# UNITED STATES PATENT AND TRADEMARK OFFICE

APPLICATION NO.	FILING DATE	FIRST NAMED INVENTOR	ATTORNEY DOCKET NO.	CONFIRMATION NO.
09/990,498	11/21/2001	Yue Ma	9432-000145	3411

**Office Action Summary**

### DETAILED ACTION

FIG. 2a

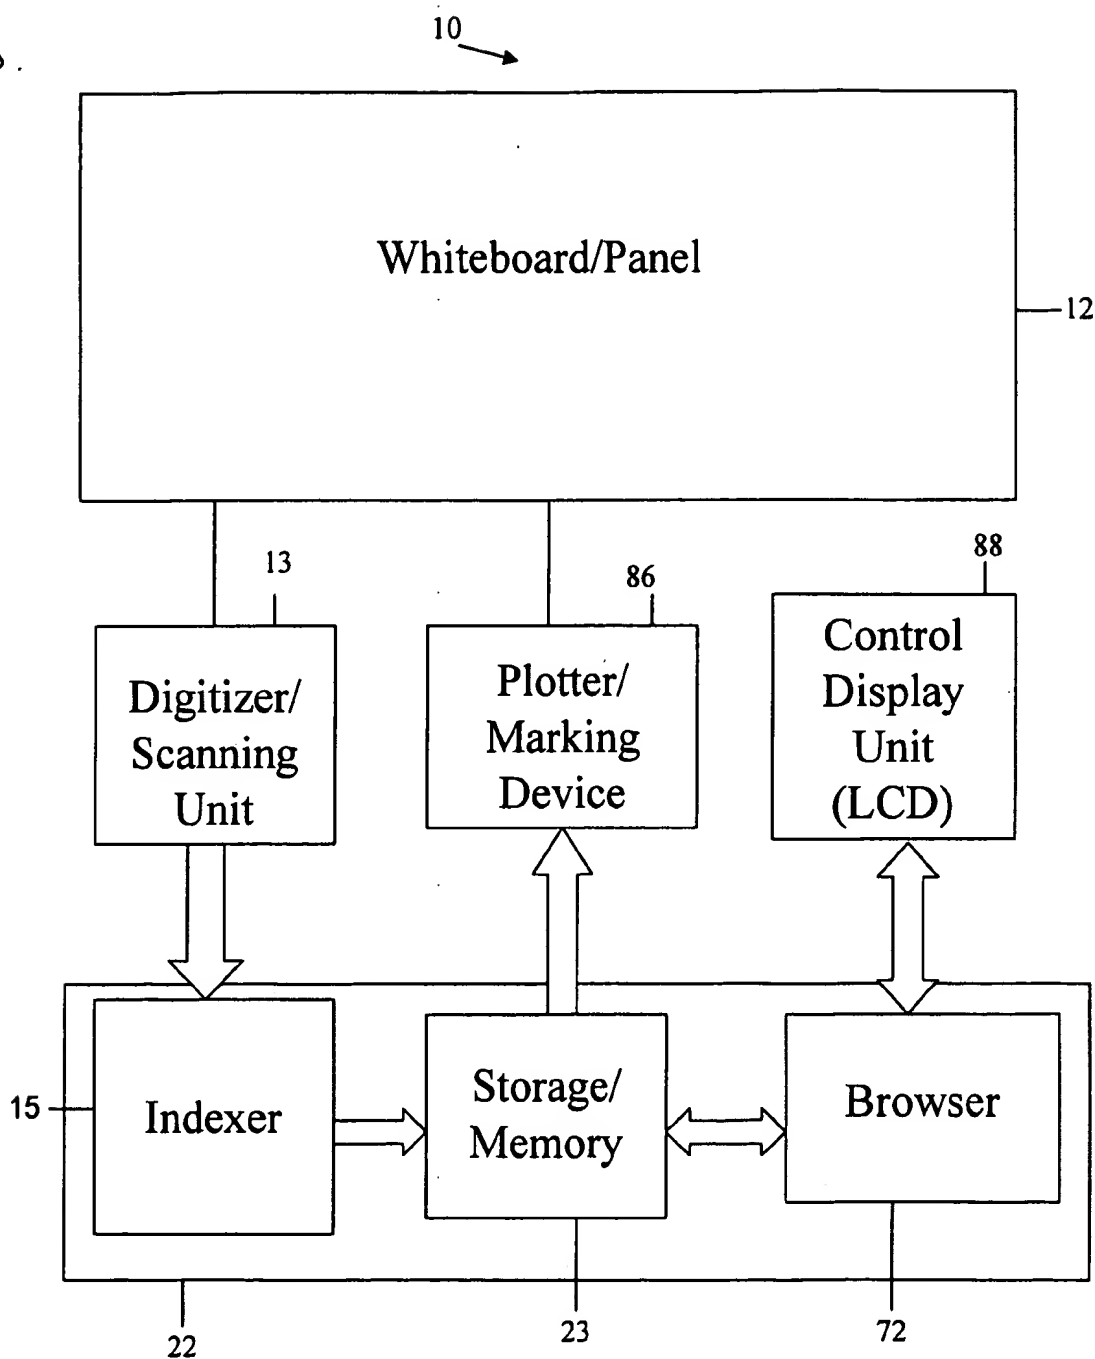
3. The drawings were received on 02/27/2006. These drawings are not acceptable because Fig. 2a introduces new matter. See the specification objection above.

DISAPPROVED.  
JHW  
5/5/06

Applicant is required to cancel the new matter in the reply to this Office Action.
